**PLANNED UNIT DEVELOPMENT
& SUBDIVISION STAFF REPORT****Date: December 15, 2016****DEVELOPMENT NAME**

Falling Leaf Subdivision, Replat of

Planned Unit Development Approval to amend a
previously approved Planned Unit Development to allow
reduced setbacks, increased site coverage, and a private
street residential subdivision, and Subdivision approval to
create 51 legal lots of record.

SITE PLAN

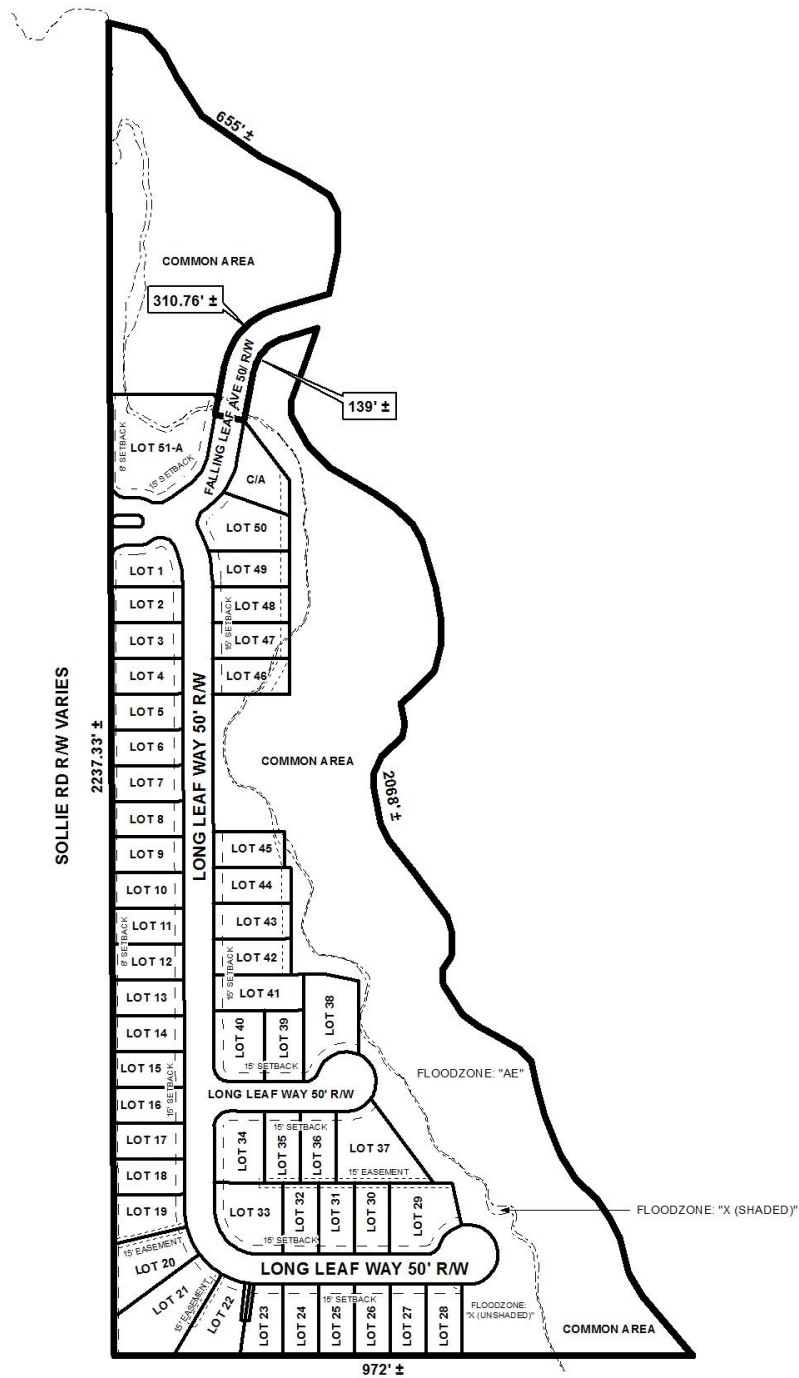
All lots will meet the minimum area requirements of the Subdivision Regulations according to the lot dimensions given although the preliminary plat does not give any lot sizes. Therefore, if approved, the plat and site plan should be revised to label each lot with its size in both square feet and acres, or a table should be furnished on the Final Plat and PUD site plan providing the same information. As increased site coverage to 45% is requested, a note should be required on the Final Plat stating the maximum site coverage allowed for all lots.

The plat indicates a 15' front setback along all street frontages within the development and an 8' rear setback for all lots abutting Sollie Road. A note on the plat lists side yard setbacks as no more than 12' combined, except for corner lots where a minimum 3' will be required on the side opposite the side street. However, the 12' combined side yards for standard lots does not specify a minimum side yard setback and could allow for a zero-lot line on one side and a 12' setback on the other side. And as some lots have drainage or utility easements along the side yards, the building setback allowances could become confusing. Therefore, the plat should be revised to show not only the specific street frontage and Sollie Road setbacks, but also the specific side yard setbacks for all lots.

The plat contains a note stating that there is a 7.5' utility easement along the front of all lots; however, this is not shown graphically on the plat. Therefore, the plat should be revised to illustrate this easement along the front of all lots. Various drainage or utility easements are indicated within the Subdivision. A note should also be required on the Final Plat stating that no structures may be constructed or placed within any easements.

As a fence is proposed along the rear of properties abutting Sollie Road, a public sidewalk along Sollie Road should be constructed at the time of fence construction. The site plan should be revised to indicate the proposed fence along Sollie Road and a public sidewalk along the Sollie Road right-of-way, or a Sidewalk Waiver application should be submitted and approved.

There is no indication on the plat or site plan of the location of the existing gates or the existing entry walls. Additionally, it is not clear if the existing gates comply with the IFC requirements for gate width. Additional comments by the Bureau of Fire Prevention may require additional revisions.

- 1) revision of the site plan to label each lot with its size in both square feet and acres, or the furnishing of a table on the site plan providing the same information;

- 2) placement of a note on the site plan stating that each lot is limited to a maximum site coverage of 45%;
- 3) revision of the site plan to show all street frontage setbacks, the Sollie Road setback and the specific side yard setbacks for all lots;

- 9) revision of the site plan to illustrate the 7.5' utility easement along the front of all lots;
- 10) placement of a note on the site plan stating that no structures may be constructed or placed within any easements;

- 11) revision of the site plan to show the existing gate feature and the existing entry wall (including the height);
- 12) revision of the site plan to show the proposed fence along Sollie Road and state its height;

- 13) revision of the site plan to show a public sidewalk within the Sollie Road right-of-way, or the submission and approval of a Sidewalk Waiver application;
